CITY OF TAYLOR, TEXAS

PLANNING AND ZONING COMMISSION MEETING

April 13, 2021, 6:00 P.M.

City of Taylor
Taylor 70 Minor Plat
PZ-2021-1274
Staff Report

TAYLOR 70 MINOR PLAT, BLOCK 1, LOT 3

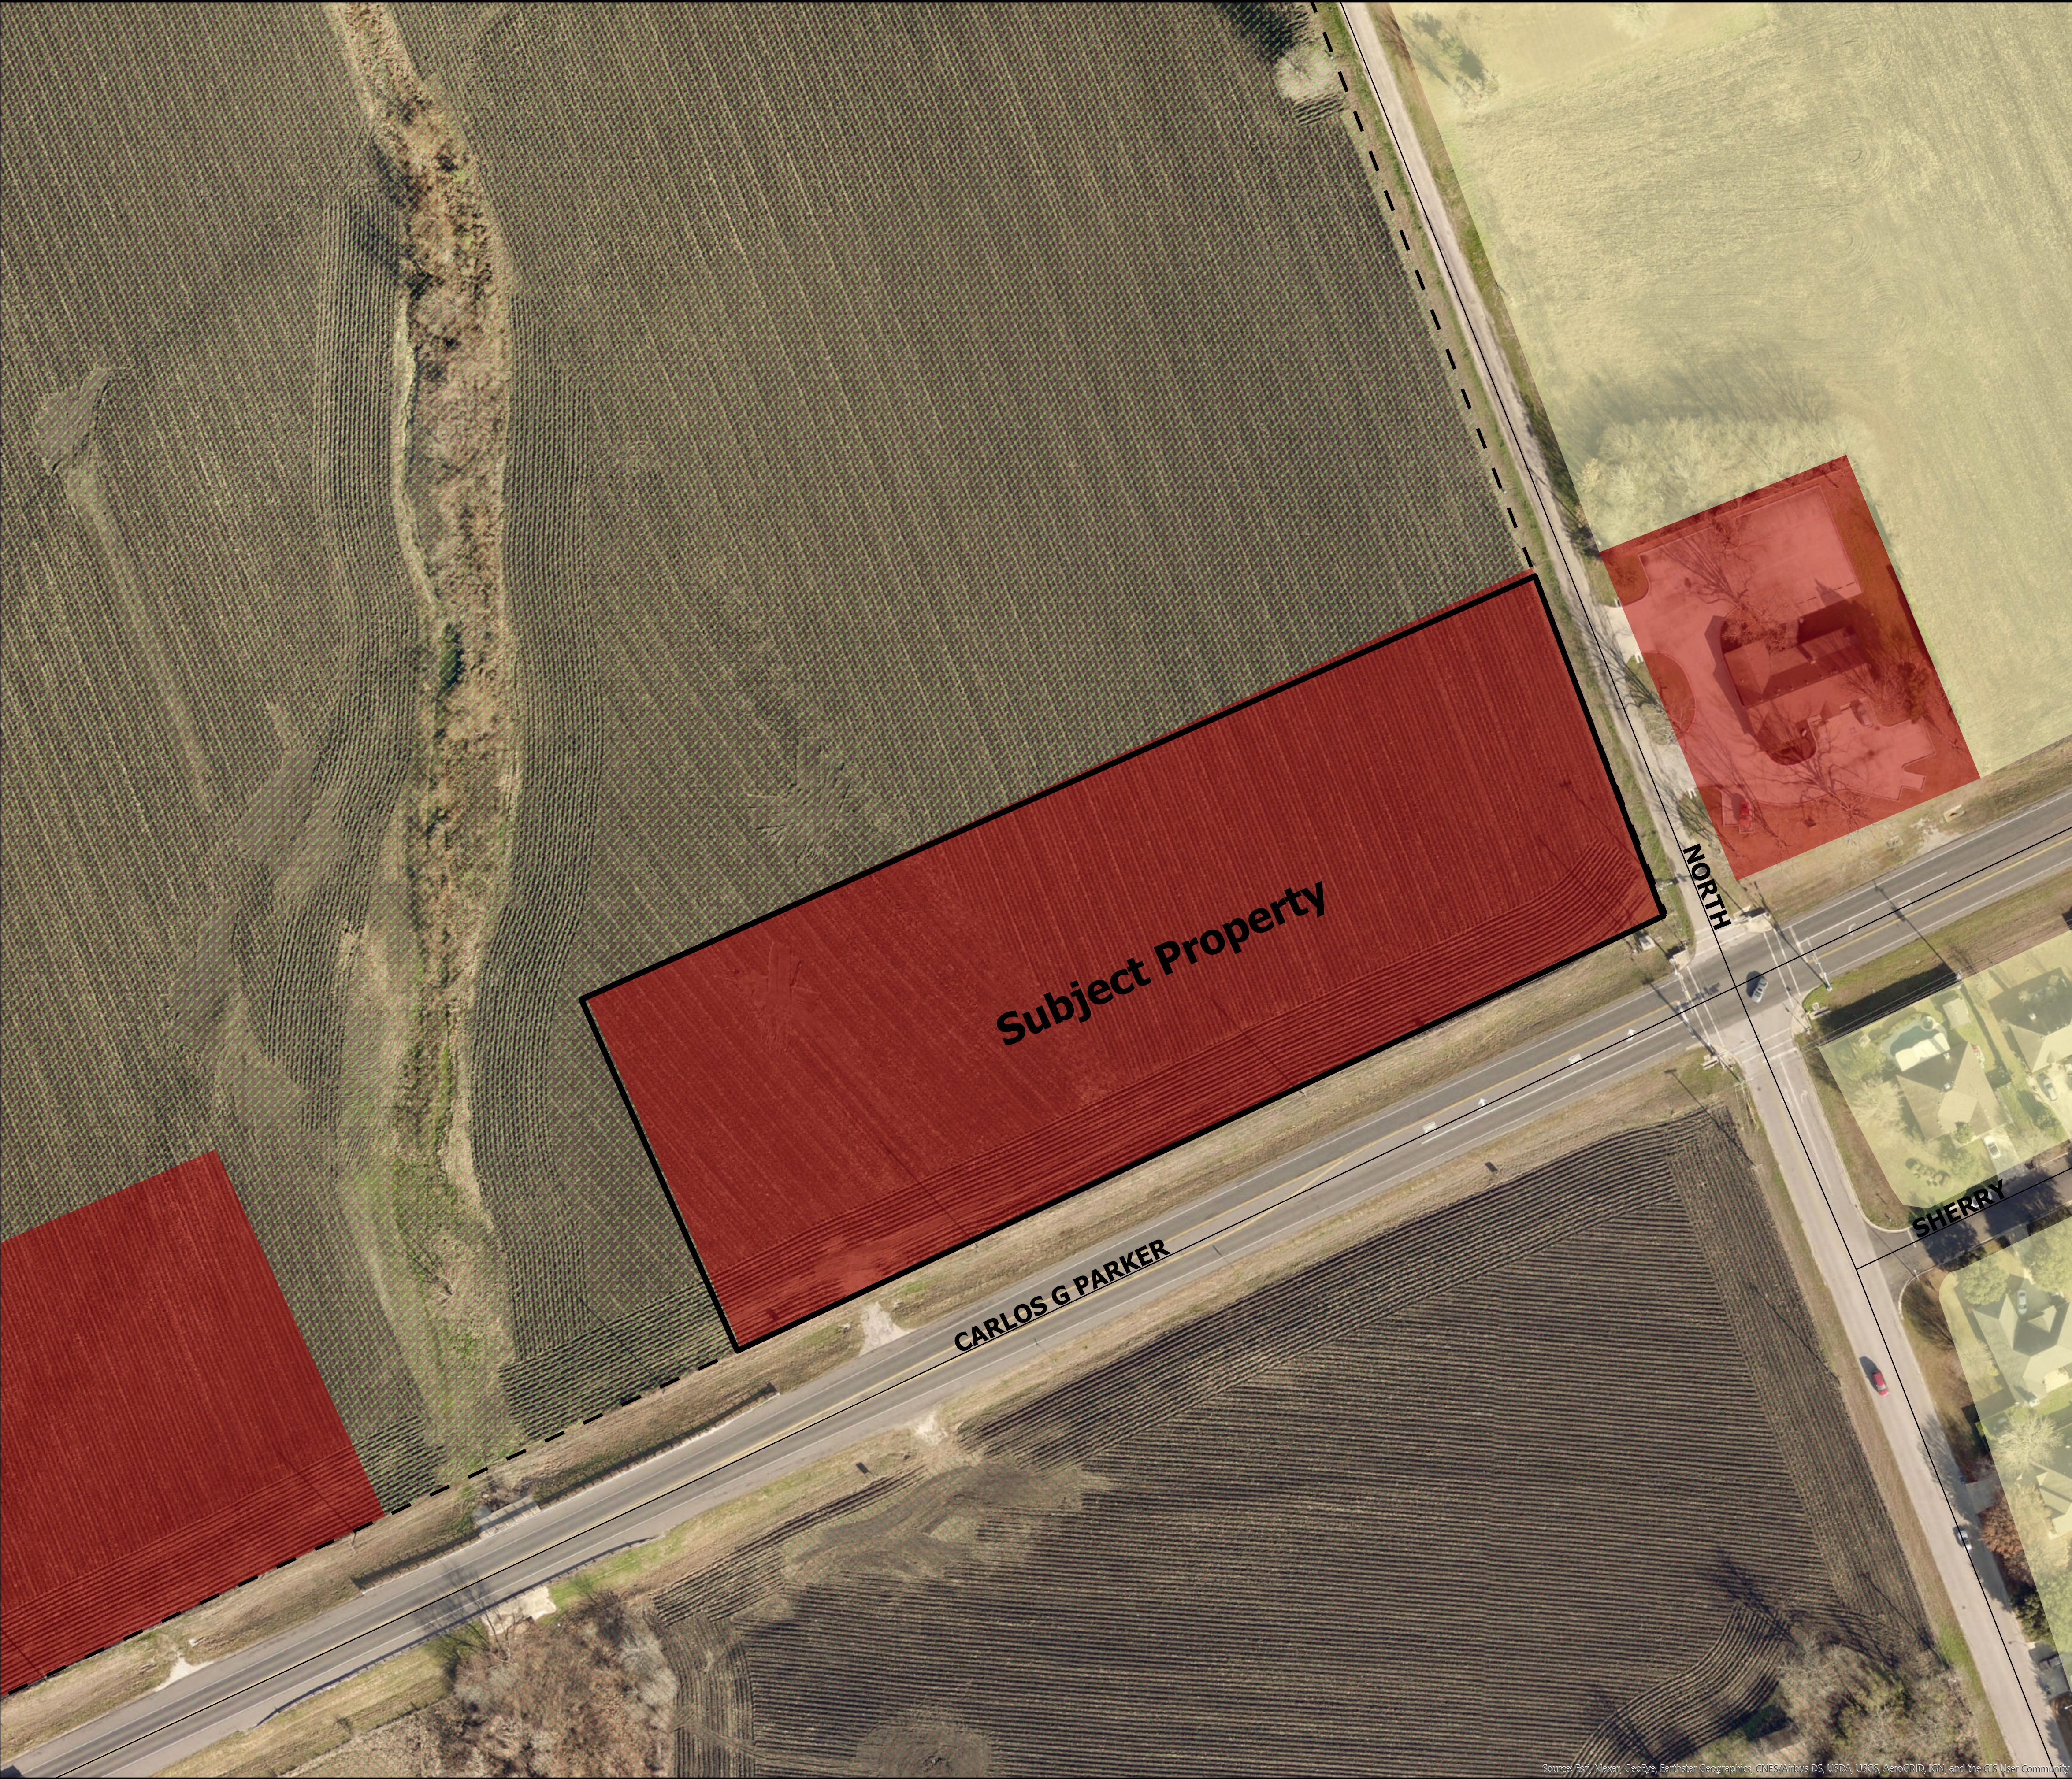
If the sidewalks are not constructed then they need to be bonded out.

Remove the Planning and Zoning Commission Certificate

DATE: OCTOBER, 2020
PROJECT: 20-276
DRAWING'S NAME: PRELIMINARY PLAN
DESIGN: CDE
CHECKED: HEJR
DRAWN: CDE
APPROVED: HEJR
SHEET: 2 OF 5

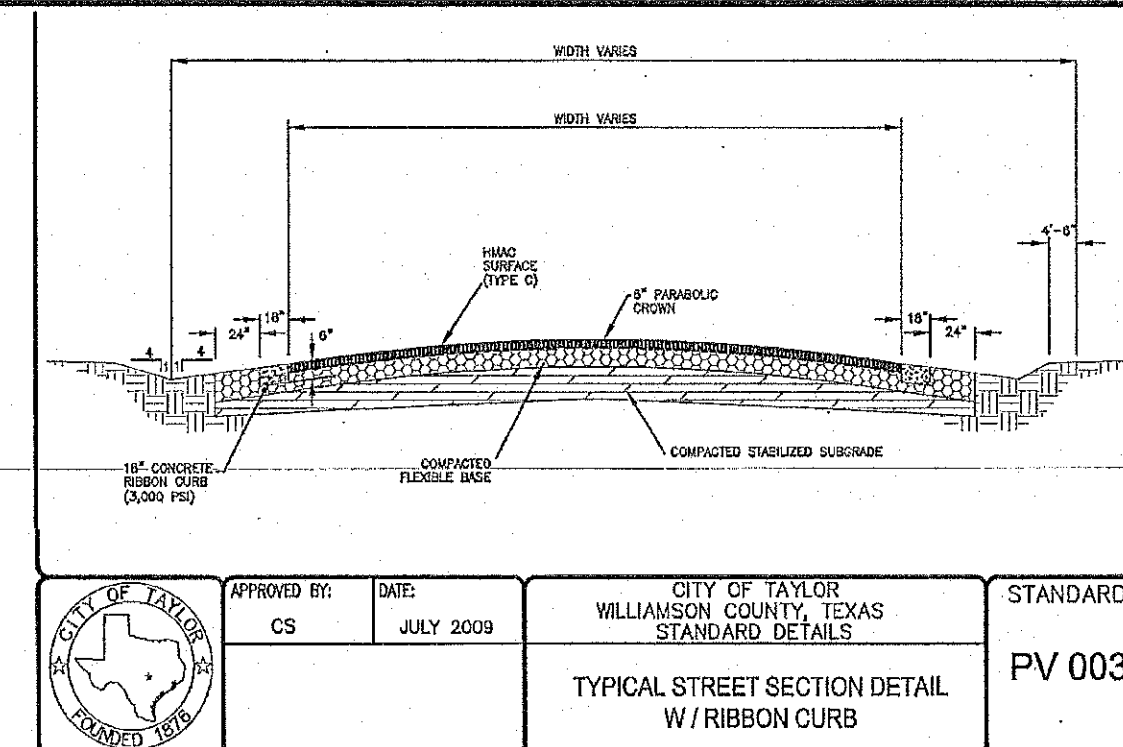
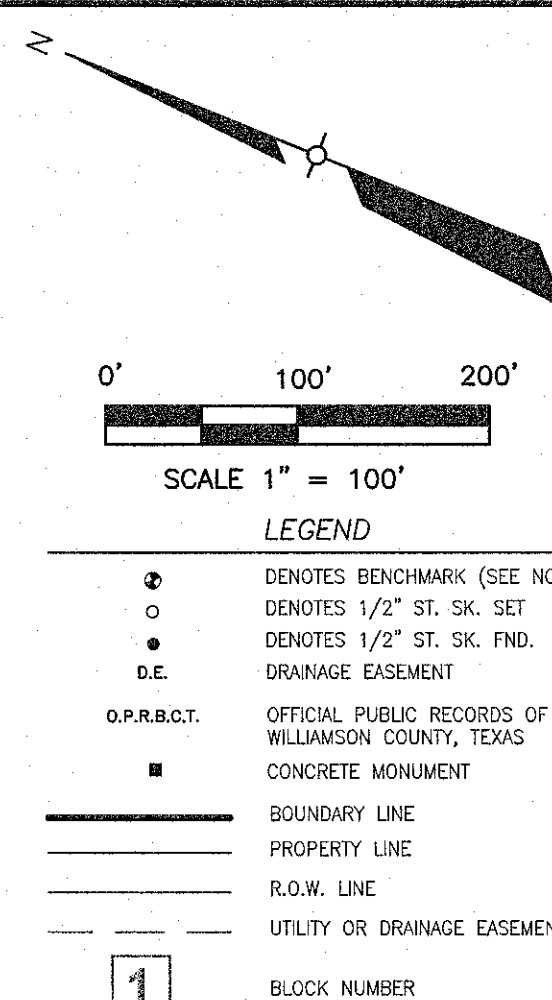
Show connectivity to the property to the north owned by Kenneth Ray Hesselmeyer. Connectivity to adjoining properties is to be provided and a one-foot easement must be provided at the stub out.

6. Though the Owner's Certificate is not required as this is a Preliminary Plat it should be corrected for the Final Plat. The is the LLC not Mr. Hyde. Change the owner's name to the LLC. If you want to add Mr. Hyde to the certificate then add, "acting through Steven Hyde" after the name of the LLC.

8. Place a Vicinity Map on the Plat Sheet. The second Sheet should have all the certificates and the metes and bounds. You don't need a Coversheet for the plat. You can have one for the Utility Plan and such if you want.

- i. The format of sheet 1 shall be provided as a plat submittal document and not an engineering plan document. Remove the sheet list table and provide other plan sheets as schematics drawings submitted separately.

- ii. The vicinity map shown shall be formatted for a plat document.
- iii. Provide a street table notating the length and service type of each street per Subdivision Application Requirements, Plat Content, 5e.

- iv. Provide a tie to an original corner of the original tract and to the closest platted lot per per Subdivision Ordinance 3.2.9c and Subdivision Application – Plat Content 6b.

- v. Verify if easement will be required for private electric facilities.
- vi. Verify if drainage easements will be required for perimeter drainage.
- vii. For all key lots shown, verify drainage easement requirements between the lots where noted on the plat review drawing.

- viii. The roadway and sidewalk shall be submitted as a separate schematic drawing and are not to be shown on the plat document.
- ix. For lots 39 and 40, these areas are to be shown as reserves for the intent of detention and for open space/utilities/drainage.

- x. Verify pump station location within lot 40 and update use of the lot shown to include this feature.
- xi. For the Texas Power & Light easement shown, provide additional information on the plat drawing to dimension the easement.

- xii. Remove the street detail and provide on a separate schematic drawing. The detail shall also consider the configuration of the roadside drainage and sidewalk.

This note shall be added to page 2 of 5 under plat note #8.

TOWN VIEW ESTATES

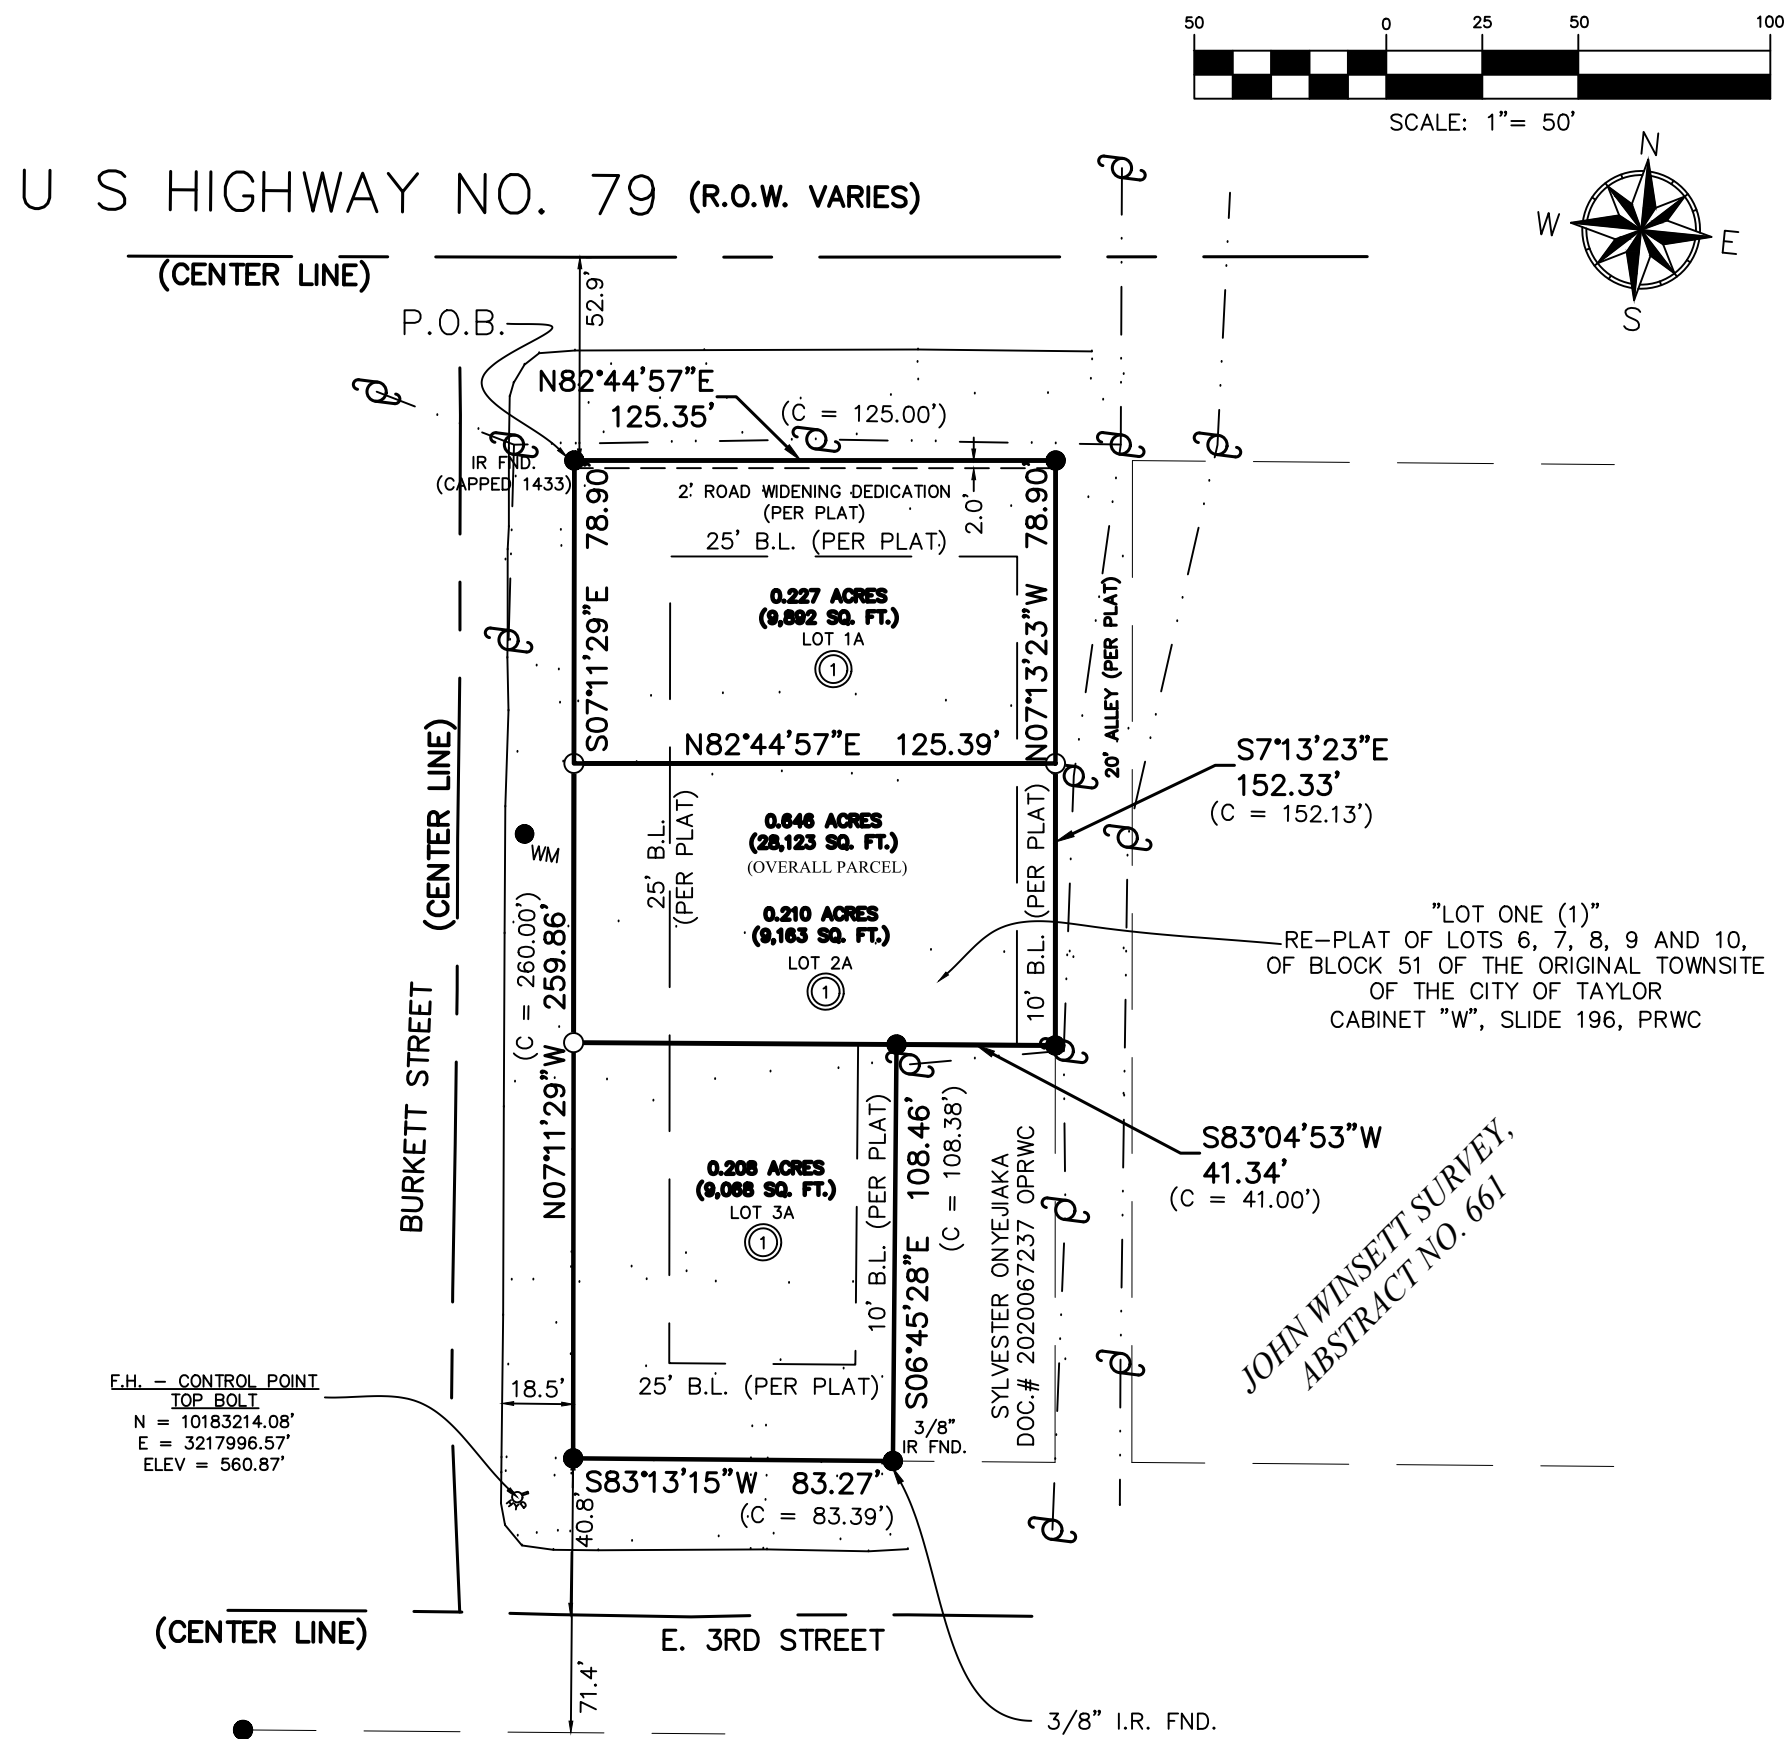
2. Provide ROW width for Burkett St. and E. 3rd St.

3. Revise all spellings of "re-plat" to "replat."

4. Revise all spellings of "certification" to "certificate."
5. Revise lot descriptions to amend the original lots (there is already a Lot 1 on the eastern section of Block 51).
 - Lot 1A to Lot 6A
 - Lot 2A to Lot 7A
 - Lot 3A to Lot 8A
6. Remove all building lines and setbacks. Revise the note about setbacks and any setbacks being shown on the plat.

1. Per Subdivision Ordinance, 2.14 the subdivider is responsible to note the location of sidewalks on the plat.
2. Provide a tie to a corner of the original tract and a tie to the closest platted lot. (reference, Plat Application, 6b.)
3. Provide a symbol in the legend for block numbering. (reference, Plat Application, 7a.)
4. Provide right of way information for Burkett St. and E. 3rd Street. (reference, Plat Application, 6g.)
5. Verify wastewater utility service for Lot 3A. Provide a utility easement to allow access to existing wastewater line in the adjacent alley. (reference Subdivision Ordinance, 2.11)
